**BALTIMORE COUNTY, MARYLAND
DEPARTMENT OF PUBLIC WORKS AND TRANSPORTATION
DIVISION OF CONSTRUCTION CONTRACTS ADMINISTRATION
111 WEST CHESAPEAKE AVENUE
TOWSON, MARYLAND 21204**

Contract No. 25010 PO0
Project No's. 107011861
Jacksonville Senior Center Expansion -
3605 Sweet Air Road, Phoenix, Maryland 21131
Phoenix – District 10c3

ADDENDUM NO. 1

DATE: 8/8/2025

SCALE: 1/2" = 1'-0"

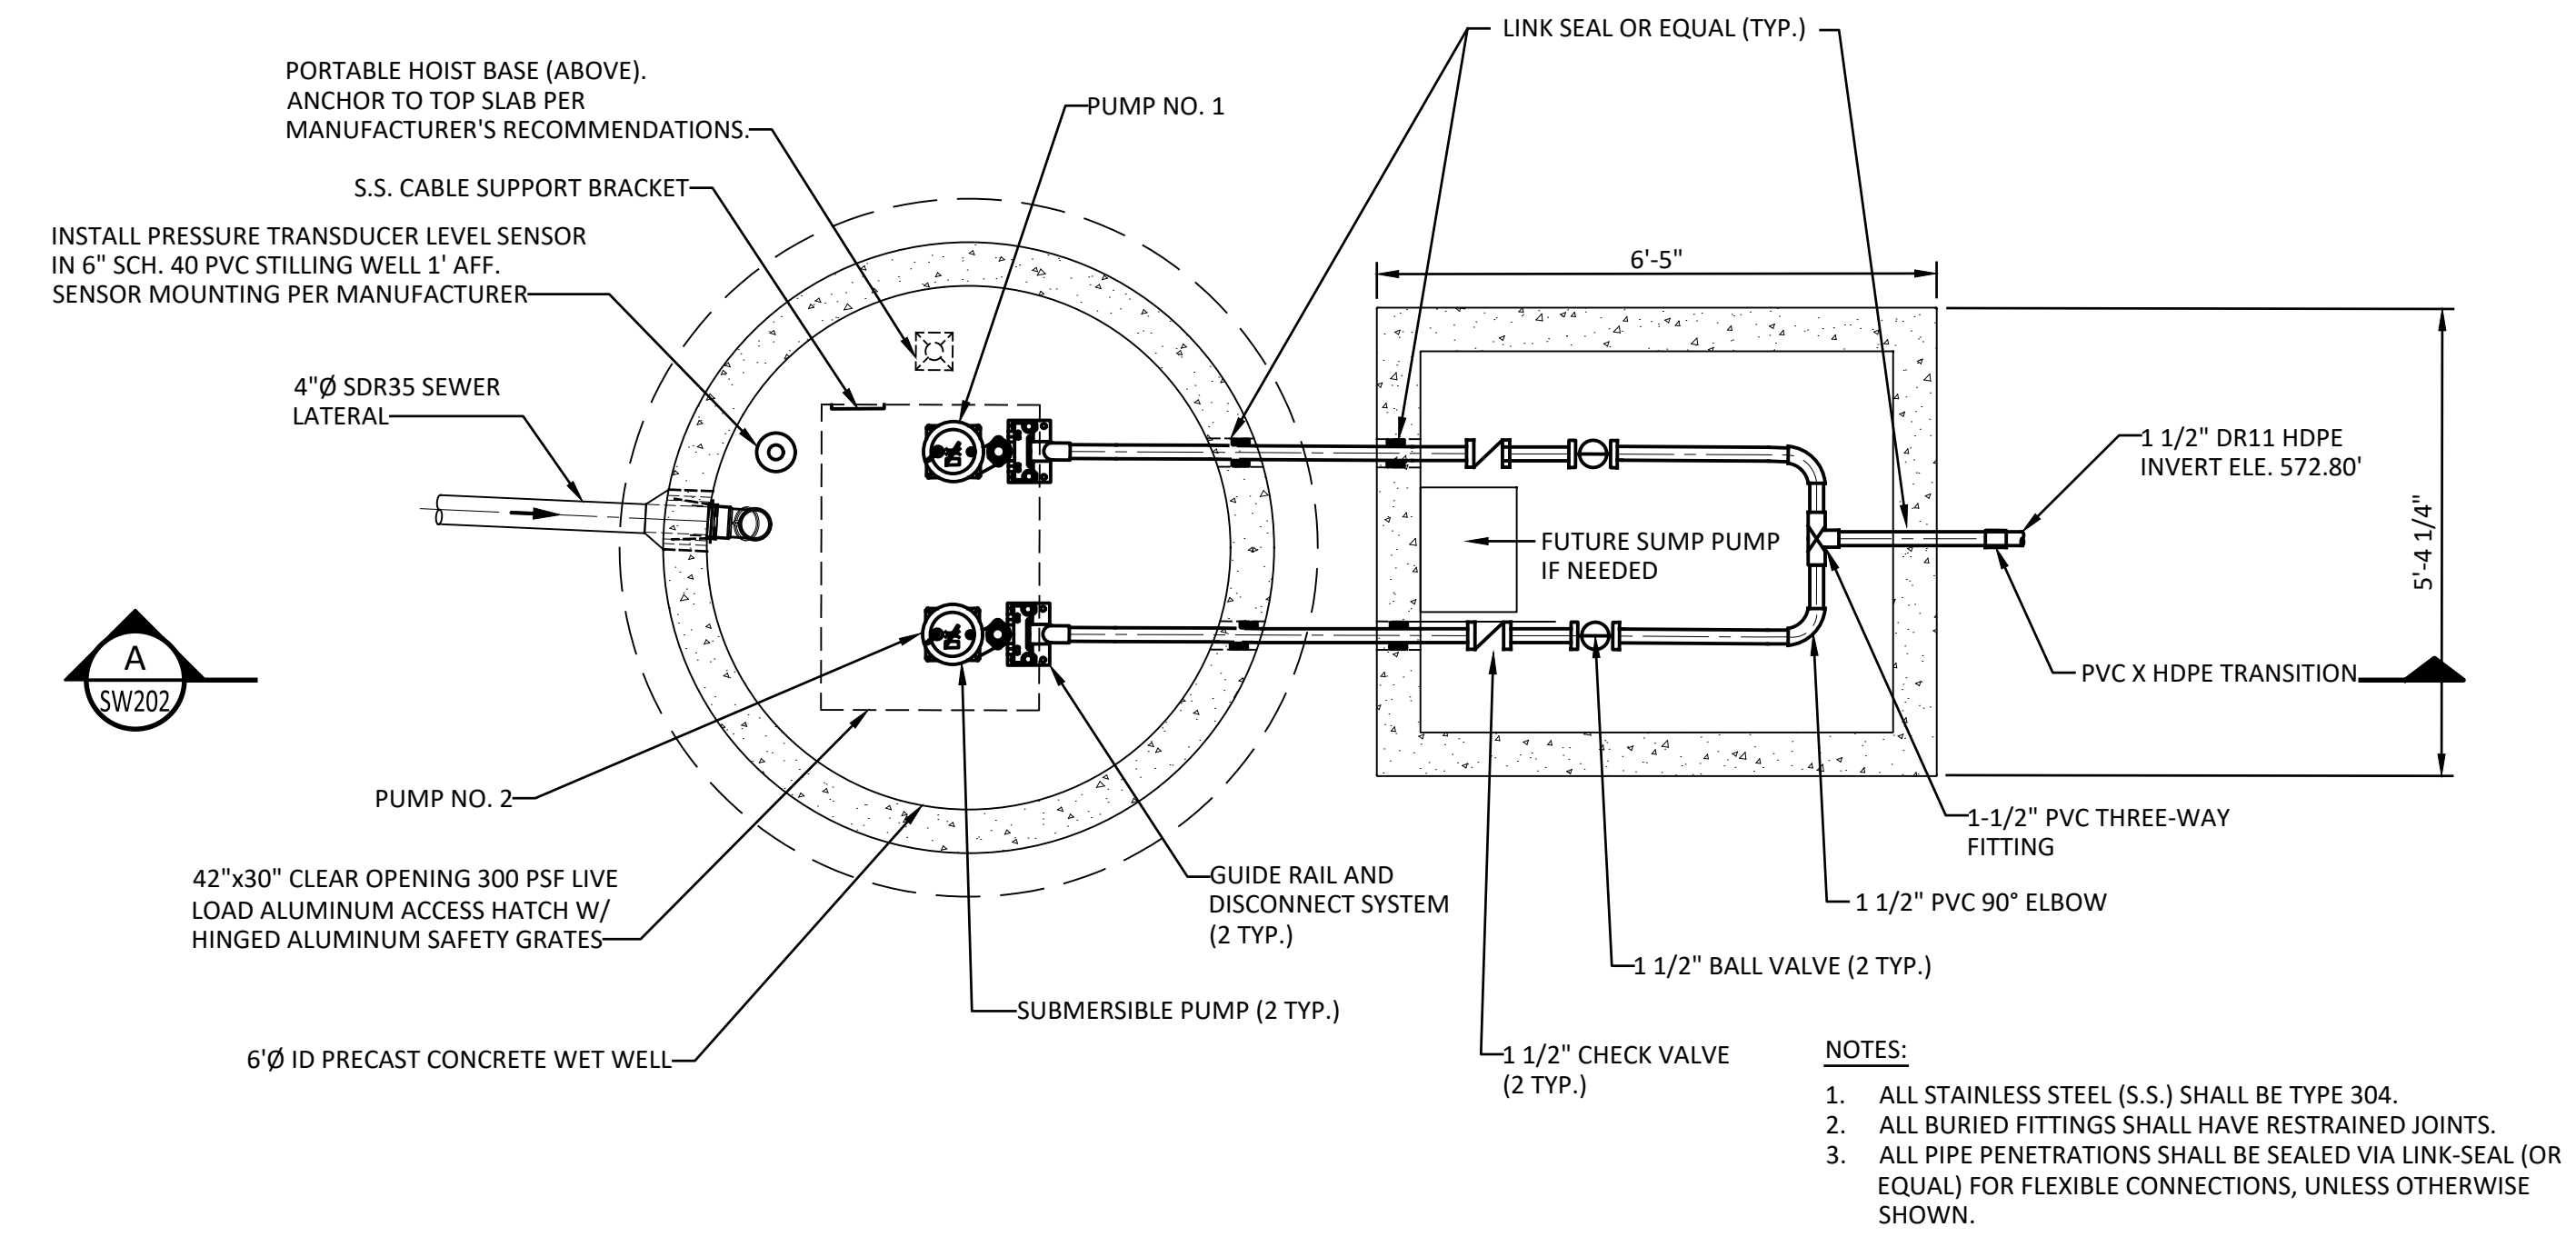
13	<p>On sheet SW202/Detail A, the finished floor elevation of the pump station is shown to be elev. 56 .00. The inlet is also shown as 56 .8. The third digit is missing in both elevations, please confirm correct elevation.</p> <p>Additionally, SW203 shows the finished floor elevation of the Pump Station to be at about 562.00 +/- . Please confirm finished floor elevation and inlet elevation of the pump station.</p>	<p>Pump Station Finished Floor Elevation = 563.00'</p> <p>Inlet Elevation is 569.8'</p>
14	<p>On the SW drawings, the invert elevation of the 4" gravity sewer coming into the pump station does not seem to match the elevations shown on the septic system profile. What is the correct invert elevation of the incoming gravity sewer into the pump station?</p>	<p>The correct inlet elevation should be 569.8'. See revised Sheet SW203 for additional elevations or schedule as shown on Sheet SW202</p>

31	Drawing SW 202 shows cross section of wet well and valve vault. Please provide elevations or heights of the structure and wall thickness. The notes on the drawing for the valve vault shows dimensions 5 – 4 1/4W- 6 - 5"L- 4-20". Not clear of the meaning 4-20".	Valve Vault Dimensions: Width = 5'-4 1/4" , Length = 6'-5", Height = 4'-9/20", and Wall Thickness = 6" See revised Sheet SW202
32	Drawing C 521 states typical section 1 concrete site wall "see structural plans." We could not find it on structural plans. Please provide sizes of footings and wall thickness.	See structural sheet S101 and corresponding wall sections.
33	Please provide sizes for footing, wall thickness reinforcements for the weir walls in MB#2.	See structural sheet S101 and corresponding wall sections.
34	On the site drawing E003 drawing note #14 it indicates that 4 of the existing site lighting poles are to be reused with new fixture heads installed on them. I have looked at the civil drawings and I don't see any information regarding these existing light poles. My question is, are these 4 existing poles being reinstalled in the same location using the same pole bases? Or are these new locations requiring new bases and conduit?	Four existing light poles are to be salvaged - refer to sheet C111, Demolition Note D-7. The existing poles will be reinstalled in new locations shown on revised sheet E003.
